ELECTRICAL LAYOUT

SURVEYED BY	DATE
DRAWN BY	DATE
TRACED BY	DATE
FRANKLIN COUNTY STATE AIRPORT	
PROJ. AIR	NO 03-2029
SHEET 3	OF 11

FRANKLIN COUNTY STATE AIRPORT
SCHEMATIC SHEET

FRANKLIN COUNTY STATE AIRPORT
AIR 03 2029
MISCELLANEOUS LIGHTING DETAILS

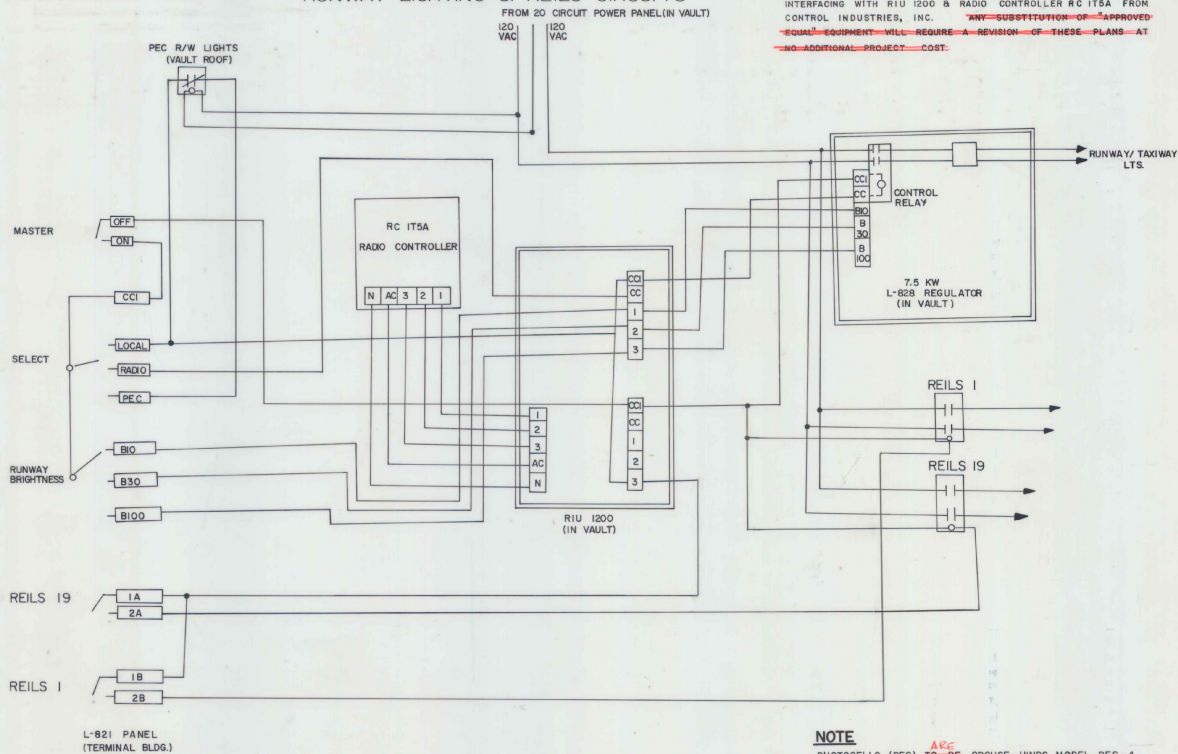
- The bare Copper Counterpoise wire (#8 AWG) ~~was~~ **was** connected to a 11 R/W and T/W light mounts and to 3/8" x 8" Copper Clad ground rods Spaced at 1000' (maximum) around lighting circuit.

- Base Mounts ~~are to be~~ **were** installed for all MRL'S, MITL'S & illuminated TAIWAY GUIDANCE SIGNS on the Eastern Side of the R/W. The offset for these installations is 10' from edge of pavement. On the Western side of the R/W, stake mounted lights ~~will be~~ **were** installed with a 10' offset from edge of pavement and empty, SEALED base mounts ~~will be~~ **were** installed with an offset of 25'. Northeastly threshold lights ~~will be~~ **were** base mounted, All other stake mounted, for details of installation of Westernly R/W lights and base mounts, See Detail E sheet 5.

- All existing underground wire disturbed by construction ~~is to be~~ **was** removed. Contractor ~~is to~~ **was** ~~make~~ **MADE** reasonable efforts to remove other unnecessary wiring located outside construction limits. Salvage ~~is to be~~ **was** property of Contractor, and the cost ~~is to be~~ **was** subsidiary to other items.

- NORTHERN RAIL'S ~~to be~~ **to be** installed @ 70' offset from R/W & ; SOUTHERN RAIL'S ~~to be~~ **to be** installed @ 100' offset from R/W &. See RAIL'S installation, Detail G sheet 5.

- Payment for CABLE MARKERS ~~is to be~~ **was** subsidiary to other items.
- Subsequent to their removal, the disposition of the ~~existing wind cone & segmented circle~~ **was** at the discretion of the Resident Engineer. ~~The existing wind cone was turned over to the maintenance div. (see spec. provisions)~~

- Two box visual Approach Slope Indicator ~~will be~~ **was** installed with a mounting height of 40'. Tilt switches ~~will be~~ **were** the cold weather type. Bid price for these units ~~will be~~ **was** included the cost of arming Bars & Calibration kit.

- ~~Should the contractor choose to install "Approved Exam" Visual Approach Slope Indicator. Requiring a #3 conductor input, forming & installing will be solely at his expense.~~

RUNWAY LIGHTING & REILS CIRCUITS

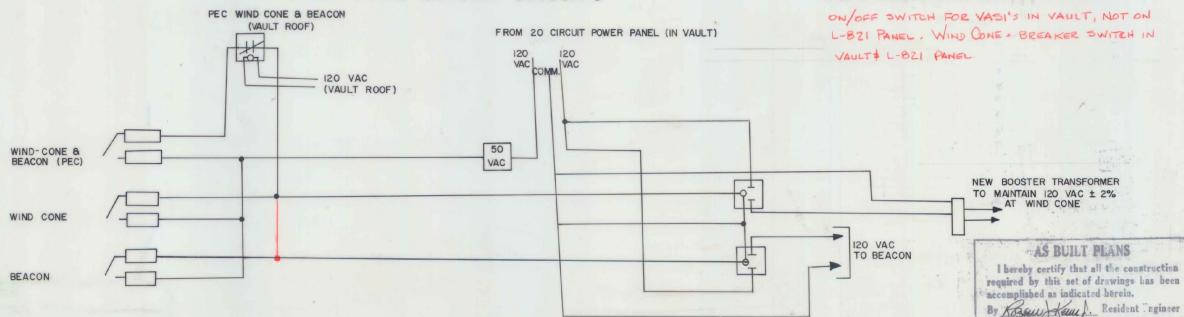
THE WIRING DIAGRAM SHOWN BELOW IS DESIGNED FOR USE WITH RADIO INTERFACING WITH RIU 1200 & RADIO CONTROLLER RC IT5A FROM CONTROL INDUSTRIES, INC. ~~ANY SUBSTITUTION OF APPROVED EQUAL EQUIPMENT WILL REQUIRE A REVISION OF THESE PLANS AT NO ADDITIONAL PROJECT COST.~~

WIND CONE-BEACON CIRCUITS

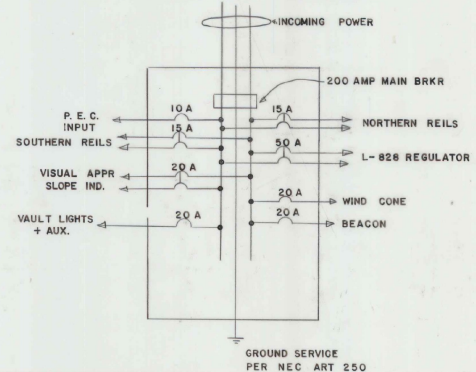
PHOTOCELLS (PEC) ~~ARE~~ ^{ARE} TO BE CROUSE-HINDS MODEL PEC-4 OR AN APPROVED EQUAL. BOTH ~~TO BE~~ ^{TO BE} MOUNTED ON NORTH WALL OF VAULT (EXTERIOR) APPROX. 8' ABOVE GROUND. ON/OFF SWITCH FOR VASI'S IN VAULT, NOT ON L-821 PANEL. WIND CONE-BREAKER SWITCH IN VAULT & L-821 PANEL.
